Manual for fixing hanging problem of SMART Relay4ch20A/6ch16A/8ch16A of Batch 3

Manual Updated Date: Aug 31, 2012, V1.0

- A. This document is used for resolving hanging problem of relay 4ch20A/6ch16A/8ch16A of batch 3.
- B. Relay PCB Version of Batch 3: V2.1, Updated date: Aug 2011
- C. Newer version V2.2 has already been resolved this problem from the PCB layout

2.1 PCB layout of Relay 4ch20 V2.1

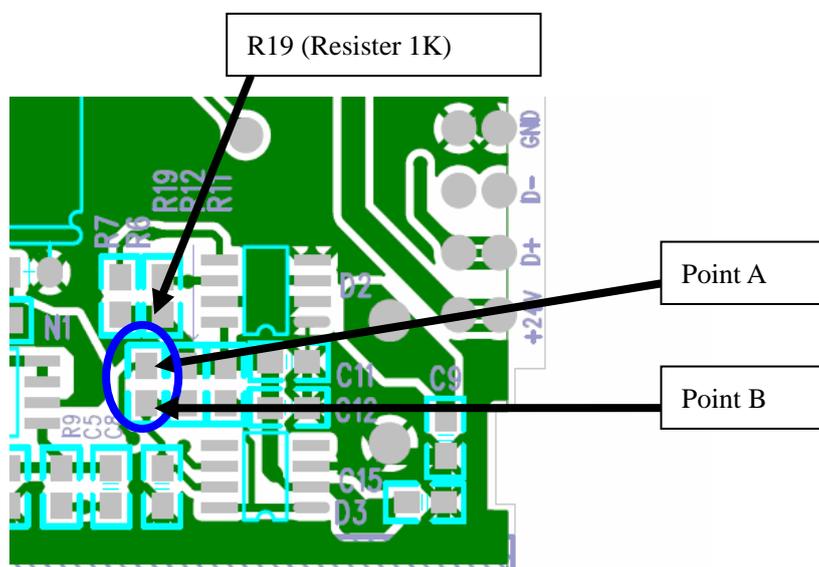
2.3 Repair resistors

2.3.1 R19 (Resistor 1K)

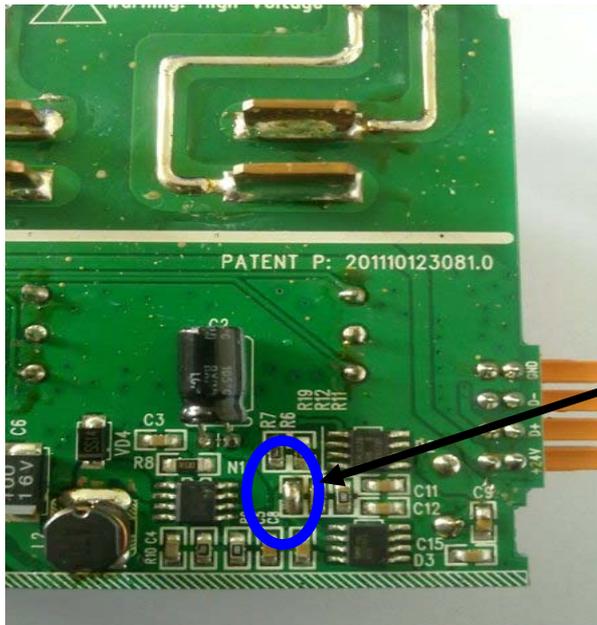
R19 is located on the back side of bottom board

STEP 1. Remove resistor R19 from PCB

this resistor of R19 will be used in other area, please keep it and don't throw it.

STEP 2. Connect Point A and Point B together by solder wire

After connected point A and Point B,
It will look like as the picture.

2.3.2 Solder resister of R19 (1K) on point C and Point D

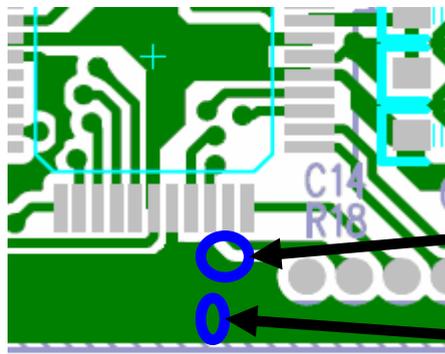
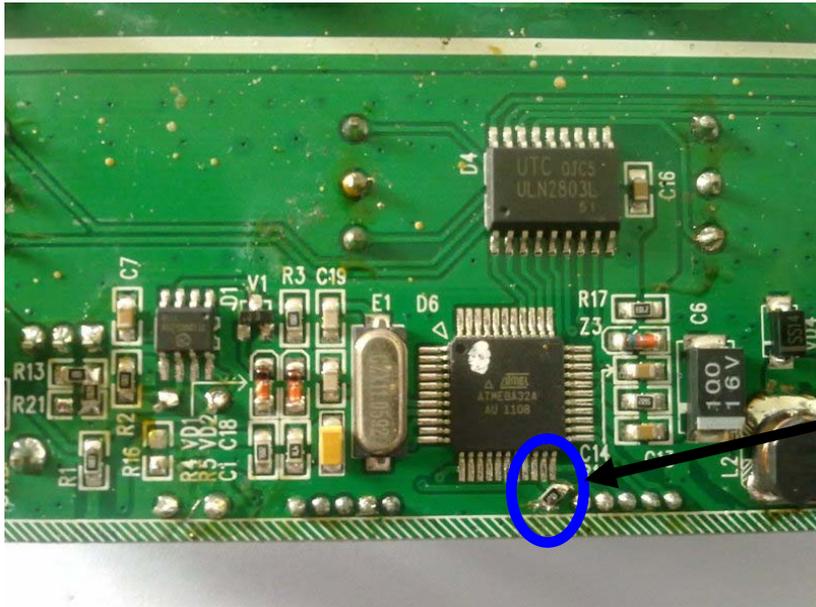
Point C, Point C is on the small track

Point D

STEP 3. Since there are no soldering points for Point C and Point D, so you need to use knife to erase a little green area on Point C and Point D as soldering points

STEP 4. Solder resister of R19 to point C and D, direction of resister is not sensitive.

R19 has been fixed on Point C and D.

2.3.3 Change the location for R21

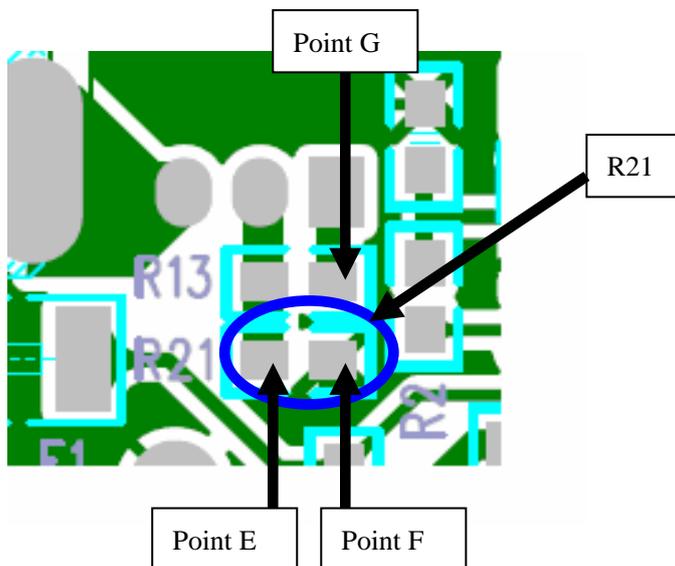
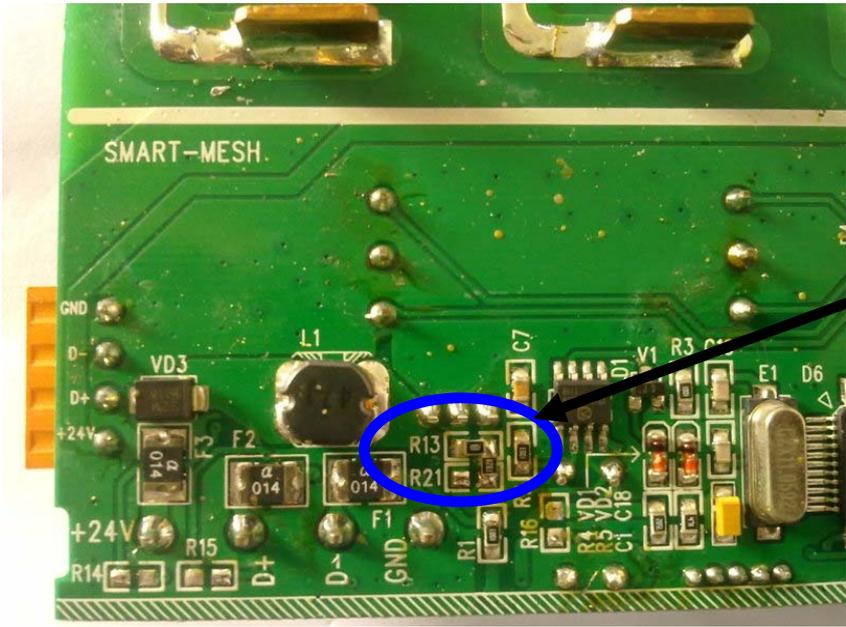
No need to change R21 for Relay6ch16A and Relay8ch16A, the following operations are only for Relay4ch20A.

STEP 5: Remove R21 from the PCB

STEP 6: Solder R21 on Point F and G, the direction of resistor is not sensitive.

R21 has been fixed.
